**Subject:** RE: bEMCAL Installation meeting Questions

**Subject:** bEMCAL Installation meeting Questions

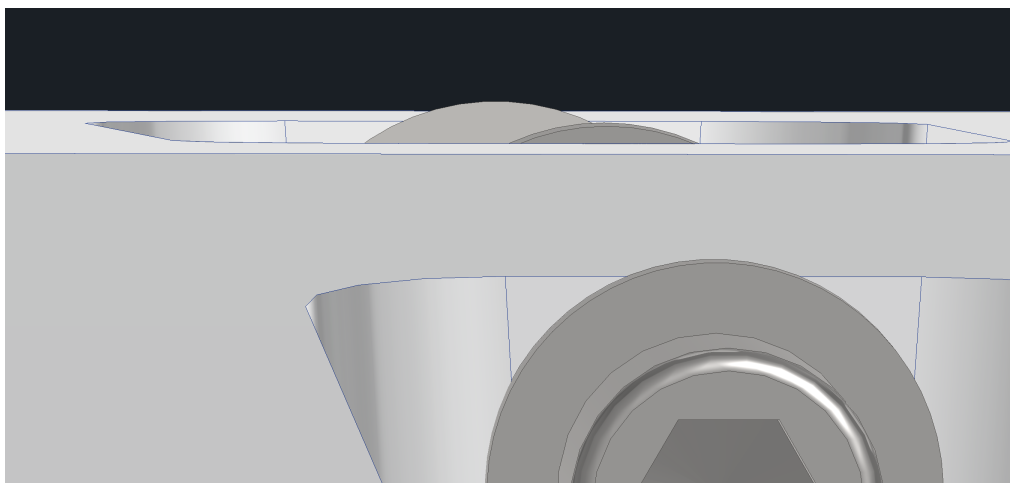
- How do you plan on moving / lifting the sectors? We have assumed that the threaded inserts on the back will be used with some other tooling for lifting, is this correct?
  - Is this lifting method compatible with installing the sectors next to one another?
- Has analysis been done on the barrel EMCAL to confirm that it is entirely self-supporting?
- What are the additional tapped holes for?

Most of those tapped holes on the outer plate are for sector construction and transportation. When building the sector there are long steel bars attached to the outer plate and they support the sector on the press. They are also used for lifting. Take a look at the attached images 5541 and 5543 to see what I mean. These bars come off when it's time to build the barrel. A different subset of these tapped holes are used for manipulating/orienting the sectors and orient in order to build the barrel. For GlueX there were two clamp-like devices that grab the sector and two chain-falls can rotate it about the long axis to orientate it properly for placement in the barrel. This is shown in images 013 and 014. We're committed to using the bars under the top plate but not necessarily so for the clamp/chain-fall approach.

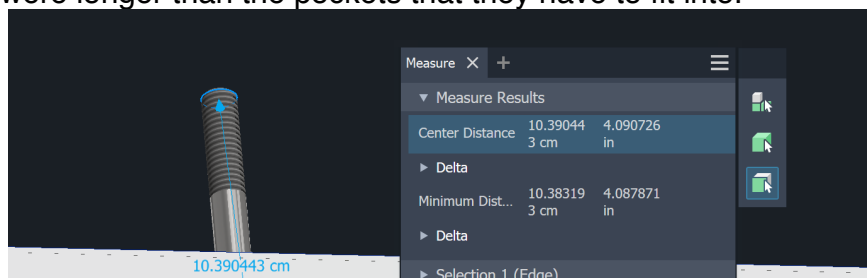
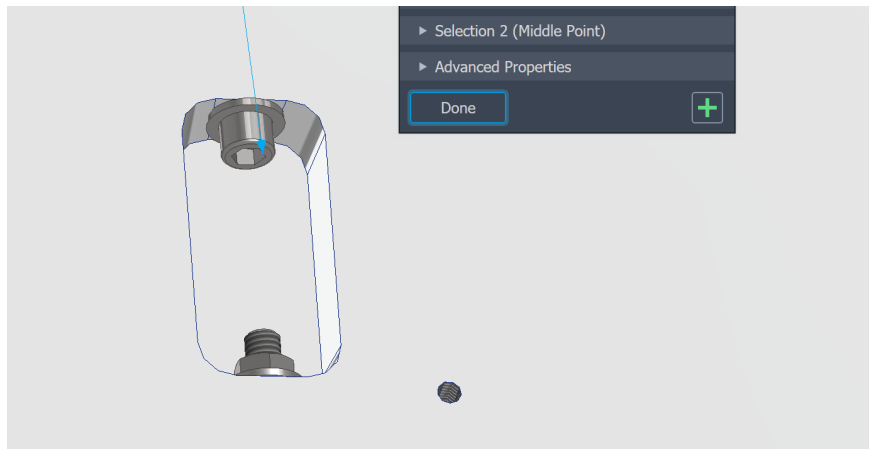
- We would like to add more of the 1/2" tapped holes along the length of the detector in a similar pattern to what already exists. They will be used to attach the support structure to the emcal. IS there any issues or concerns with this? Also can they be made 5/8"?
- Can the pockets be made deeper such that the washers don't stick proud of the face?

- While looking at the model today we noticed that the bolts that connect the sectors were longer than the pockets that they have to fit into.

I don't see any problems with adding more holes. We can even re-position some of the existing ones if that helps.

The pockets can be made deeper if necessary. The pocket idea also comes from GlueX. At some point in the past Dan designed a joining plate to connect the sectors that bolted onto the back of our outer plate. That might be a good alternative to consider.

Good catch on the screw length! If we stick with the pockets we can make them longer or perhaps put a threaded insert in the hole on the adjacent sector and eliminate the nut.
